**From:** [REDACTED]  
**To:** <pi@aberdeencity.gov.uk>  
**Cc:** "Marie Boulton" <mboulton@aberdeencity.gov.uk>; <mmalik@aberdeencity.gov.uk>; "Aileen Malone" <amalone@aberdeencity.gov.uk>  
**Sent:** 16 May 2014 14:10  
**Attach:** Dunmail Planning Application.odt  
**Subject:** Planning Application 140568  
Birchlea  
1 South Avenue  
Cults  
Aberdeen  
AB15 9LP

**REPRESENTATIONS BY DAVID L. McFARLANE on the Planning Application 140568 for the demolition and redevelopment of Dunmail, South Avenue, Cults, Aberdeen.**

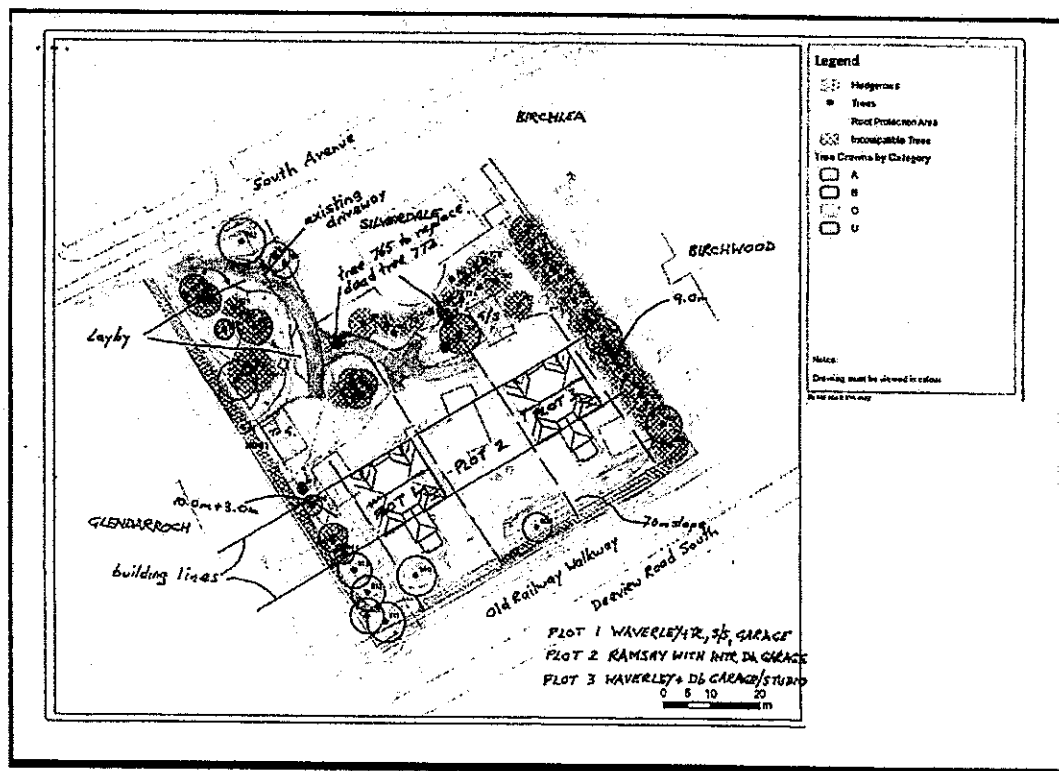
**Zone 1:** Northwest corner containing existing driveway access to South Avenue and trees 762, 763, 764, 818, 819, 820, 822, 823, 824 and 825 (11 trees)(Age 8M + 3SM) (Condition 8G + 3F) (BRP 11 K3) (Quality Category 7A2, 1B2 + 3C2) (Unviable NIL) (Incompatible with design 7 trees 819 to 825 incl.) Hence the Survey does not identify any arboricultural reasons for the removal of any of the trees within Zone 1. The only reason given for the removal of trees 819 to 825 (7 No) is that they are incompatible with the design of the realigned and wider access driveway. It is submitted that if the development requires a wider driveway then the existing driveway could be widened using the procedures and technology detailed in Para 5.2 of the Tree Survey document. Accordingly in consideration of the foregoing, the TPO 159, Policy NE5 and the Tree Survey information it is submitted that no trees should be removed from Zone 1.

**Zone 2:** Area to the south of Silverdale containing trees 765 to 787 (23 trees) (Age 16Y + 6M + 1SM) (Condition 21G + 1P + 1D) (BRP 23K3) (Quality Category 5A2 + 17C2 + 1U) (Unviable tree 772 dead) (Incompatible with design 773 to 787 incl. 15 No). Hence with the exception of tree 772 that is dead the Survey does not identify any arboricultural reasons for the removal of any of the trees within Zone 2. The only reasons given for the removal of trees 773 to 787 incl. (15No) is that they are incompatible with the design because they prevent the development of Plot 4, Roxburgh with Quad Single Storey Garage and the new access driveway. Accordingly in consideration of the foregoing, the TPO 159, Policy NE5 and the Tree Survey information it is submitted that with the exception of tree 772 that is dead no trees should be removed from Zone 2. The substantial neatly trimmed cypress hedge on the southern boundary of Silverdale has not been included in the Tree Survey.

**Zone 3:** The line of trees adjacent to the east boundary between Dunmail and Birchwood containing trees 788 to 808 (21 trees) (Age 20M + 1SM) (Condition 21P) (BRP 1K1\* + 7K1 + 1K2 + 12K3) (Quality Category 2U + 19C2) (Unviable Trees 798 + 807 i.e. 2 No) (Incompatible with design all 23 trees). Table 2-2 describes Condition Category "Poor" as "A tree in poor structural condition with defects that could not be easily remedied". This suggests that the defects might be remedied albeit with some difficulty. The Survey lists "past poor management including repeated heavy reductions and poor finish cuts". For over 10 years these trees have been included in TPO 159 and as such any pollarding work was authorised by the City Council which authorisation would have required the tree work to be done by professionals approved of by them with the work inspected on completion. Clearly the Tree Survey is criticising the City Council tree management under the TPO procedures. Seven trees in Zone 3 have definite bat roost potential with one tree, 788, having highly suitable features capable of supporting larger roosts. Para 2.3.6 and Para 5.3.3. recommends that an elevated survey for the presence of bats should be undertaken prior to scheduling any tree removal. It is submitted that a Bat Survey should be undertaken for the whole of the Dunmail policy including the house. If bats are found to be present I understand that a Bat Licence is required before the bats are disturbed by tree felling etc. and / or demolitions. Furthermore I understand that obtaining a licence is not a formality. Without the results of a Bat Survey and, if necessary the results of a Bat Licence Application the trees in Zone 3 must remain a constraint to the development some 9m wide adjacent to the eastern boundary with Birchwood. Moreover a decision must be taken to determine whether the condition of the trees in Zone 3 can or cannot be remedied. Currently these deciduous trees are showing a healthy leaf cover.

**Zone 4:** The southern boundary area containing trees 809 and 810 together with HGD2 an overgrown Lawson's cypress hedge. Trees 809 and 810 (2 trees) (Age 1M + 1SM) (Condition 2G) (BRP 2K3) (Quality Category 2B2) (Unviable trees NIL) (Incompatible with design NIL trees but HGD2 recommended for removal). The Survey does not recommends any of the two Cherry Trees for removal but suggests that HDG2 could be replaced with a Beech hedge or a mix of native hedgerow including thorn species which would not be a constraint to development.

**Zone 5:** The line of trees adjacent to the southern half of the western boundary between Dunmail and Glendarroch containing trees 811 to 817 + 826 (8 trees) (Age 6M + 2SM) (Condition 3F + 4P + 1D) (BRP 4K1 + 1K2 + 3K3) (Quality Category 6U + 2B2) (Unviable trees 811, 812, 814, 816, 817 and 826 i.e. 6 trees) (Incompatible with design 814, 815, 816 and 817 i.e. 4 trees). Table 2-2 describes Condition Category "Poor" as "A tree in poor structural condition with defects that could not be easily remedied". This suggests that the defects might be remedied albeit with some difficulty. The Survey lists "past poor management including repeated heavy reductions and poor finish cuts". For over 10 years these trees have been included in TPO 159 and as such any pollarding work was authorised by the City Council which authorisation would have required the tree work to be done by professionals approved of by them, with the work inspected by them on completion. Clearly this Tree Survey is criticising the City Council tree management under the TPO procedures. Four trees in the Zone 5 have definite bat roost potential. Para 2.3.6 and Para 5.3.3. recommends that an elevated survey for the presence of bats should be undertaken prior to scheduling any tree removal. It is submitted that a Bat Survey should be undertaken for the whole of the Dunmail policy including the house. If bats are found to be present I understand that a Bat Licence is required before the bats are disturbed by tree felling etc. and / or demolitions. Furthermore I understand that obtaining a licence is not a formality. Without the results of a Bat Survey and, if necessary the results of a Bat Licence Application the trees in Zone 5 must remain a constraint to the development some 13m wide adjacent to the western boundary with Glendarroch. Moreover a decision must be taken to determine whether the condition of the trees in Zone 5 can or cannot be remedied. Currently these deciduous trees are showing a healthy leaf cover.

**This assessment of the Tree Survey information, independent of the development masterplan, demonstrates that the constraints of the existing trees leaves a central development area measuring some 54m east to west by some 37m north to south (including the slope near the southern boundary) which is sufficient for 3 plots measuring 18m by 37m each or 2 plots measuring 27m by 37m each.**

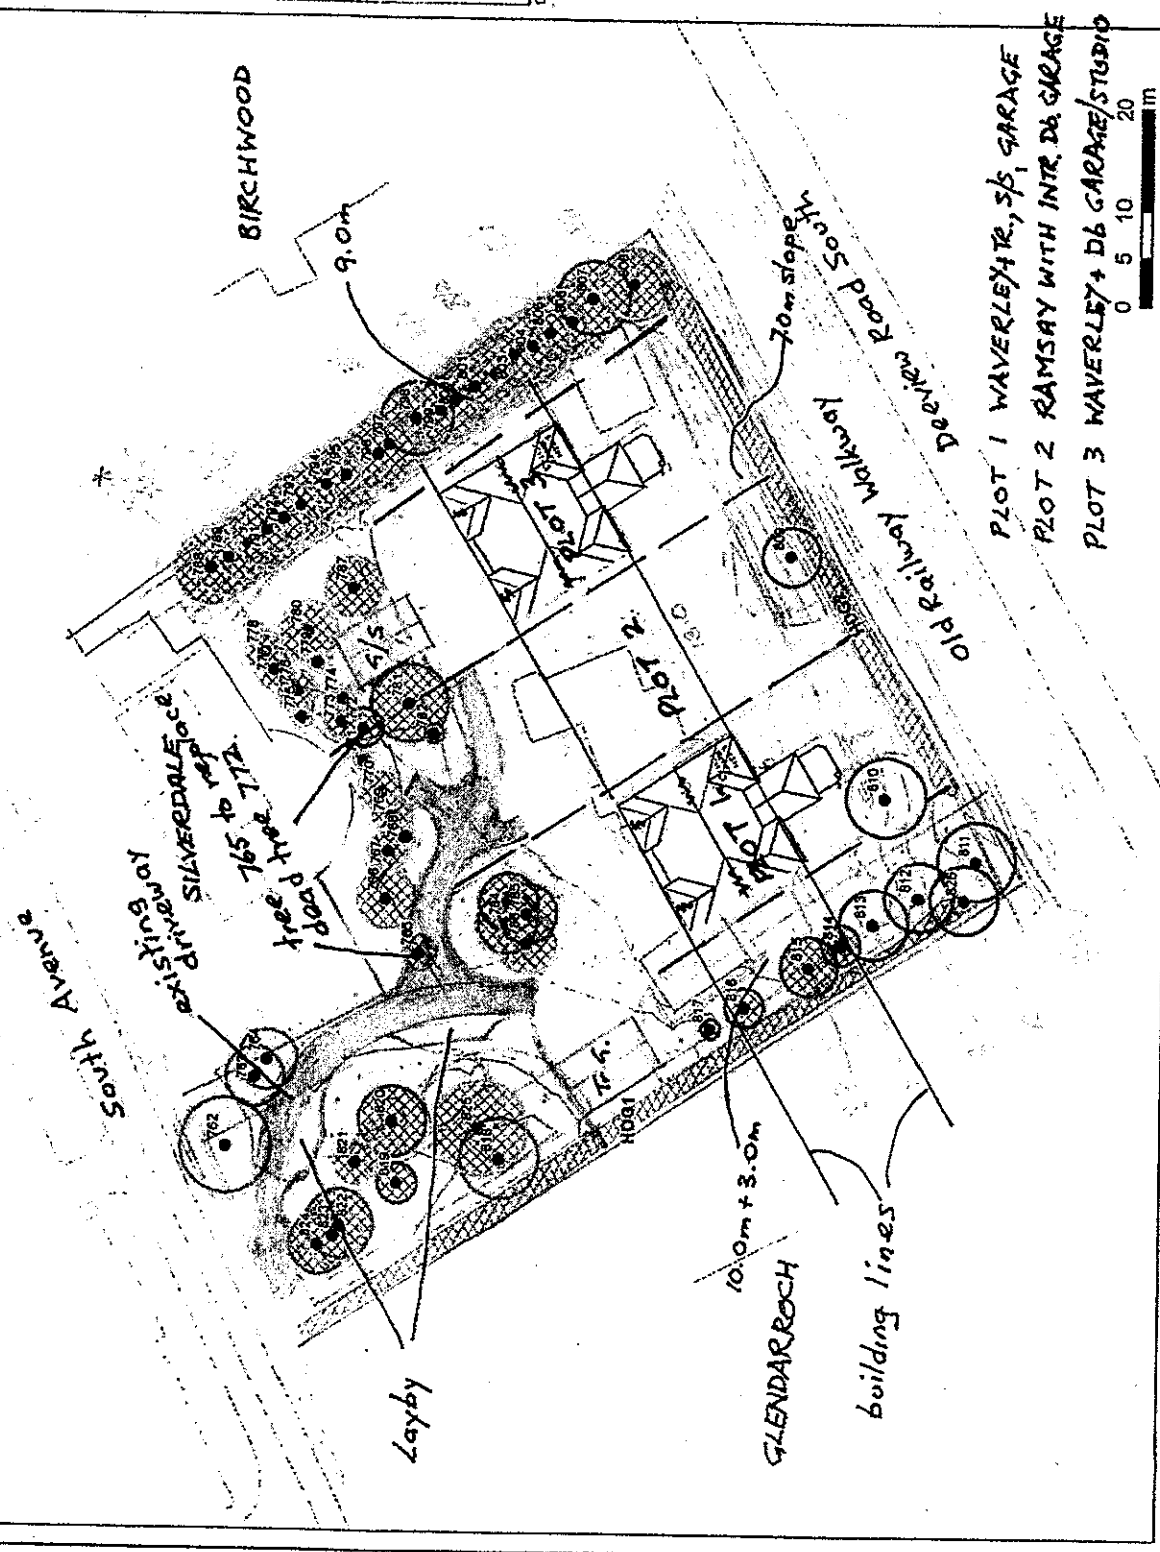
The CALA Masterplan shows the footprints of Birchwood and Silverdale incorrectly. The missing extension westwards from Birchwood has windows facing the kitchen window of Plot 3. The two single storey garage buildings have ridge heights of 5.3m (not 5.0m) in the title restriction areas. All 21 trees adjacent to the Birchwood boundary are to be replaced by only 9 trees of uncertain species and size.
